Access Compliance Report Public Rights-of-Way (Curb Ramps)

Main Street: OSO_PKWY		Cross Street: N/A		Location: NE
ADA ID: RPAT220208112553	Ramp Type: Type 4 - Parallel	Initial Pass/Fail: Fail	Overall Compliance: No	Severity Score: 15

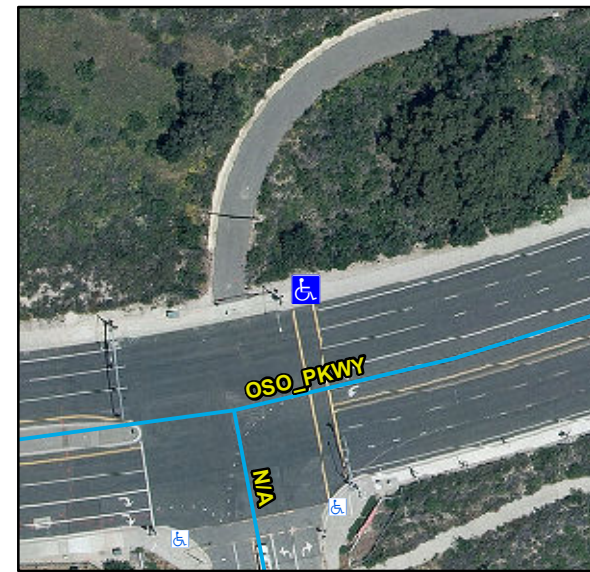
Compliance	Description	Data	Compliance	Description	Data
N/A	Ramp Length LT (in)	107	N/A	Ramp Length RT (in)	100
Yes	Ramp Width LT (in)	82	Yes	Ramp Width RT (in)	82
No	Ramp Run Slope LT (%)	9.46	Yes	Ramp Run Slope RT (%)	5.3
Yes	Ramp Cross Slope LT (%)	0.1	Yes	Ramp Cross Slope RT (%)	1.12
N/A	Landing Present	N/A	N/A	DWS Provided	N/A
N/A	Landing Length (in)	N/A	N/A	DWS Contrast	N/A
N/A	Landing Width (in)	N/A	N/A	DWS Length (in)	N/A
N/A	Landing Run Slope (%)	N/A	N/A	DWS Full Width	N/A
N/A	Landing Cross Slope (%)	N/A		DWS Offset Type	N/A
N/A	Landing Movement Obstructed?	N/A	N/A	DWS Offset Left (in)	N/A
	Landing Movement Type	N/A	N/A	DWS Offset Right (in)	N/A
N/A	Landing Shared	N/A			
N/A	Clear Space	N/A			
N/A	Clear Space To Crosswalk (in)	N/A			
N/A	Marked Crosswalk 1	Yes	N/A	Marked Crosswalk 2	N/A
	Crossing 1 Direction	S		Crossing 2 Direction	N/A
	Marked Crosswalk 1 Width (in)	145		Marked Crosswalk 2 Width (in)	N/A

N/A	Ramp Inside Crosswalk 1	Yes	N/A	Ramp Inside Crosswalk 2	N/A
	Crossing 1 Slope (%)	5.4		Crossing 2 Slope (%)	N/A
	Crossing 1 Cross Slope (%)	3.3		Crossing 2 Cross Slope (%)	N/A
N/A	Gutter Ponding	N/A	N/A	Curb Slope	13.3
Yes	Gutter Lip Height (in)	0		Road Run Slope (%)	N/A
N/A	Gutter Run Slope (%)	N/A		Road Cross Slope (%)	N/A
N/A	Gutter Cross Slope (%)	N/A	Yes	Perpendicular Joint Present	Yes
Yes	Overall Surface Condition	Acceptable			
	Cross Gutter Present?	No		Spandrel Present?	No
	Replace Cross Gutter?	N/A		Replace Spandrel?	N/A

Remove & Replace Entire Ramp.

R304.3.2, STD 1115
